INTERIOR DOOR PANEL RATTLE—ROUGH ROAD SURFACES—BUILT ON OR BEFORE 1/8/2013

TSB 13-5-3

FORD:
2013 Fusion

LINCOLN:
2013 MKZ

Figure 1 - Article 13-5-3

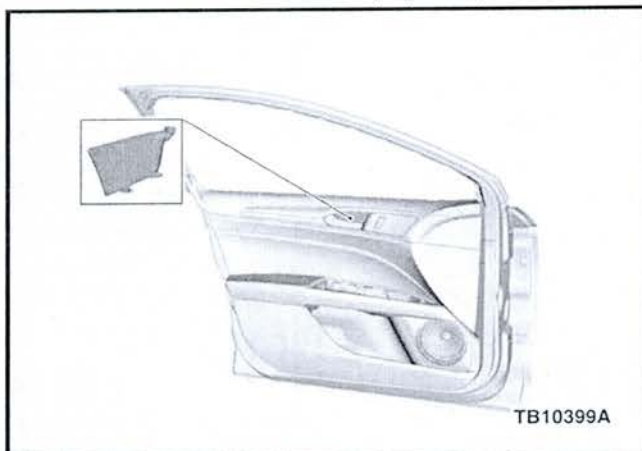
1. Remove door trim cover. (Figure 1)

- a. Using a suitable tool, pull the front of the trim cover first to prevent damage.
 - b. If any of the four tabs are broken, replace the trim cover. Proceed to step 2.
2. From the Rotunda Squeak and Rattle Kit (part number 164-R4900) select one PVC soft foam tape strip (part number 164-R4901).
 - a. Cut a foam tape strip to a size of 10 mm (3/8") wide by 25.4 mm (1") long and apply it to the back side of the cover. (Figure 2)
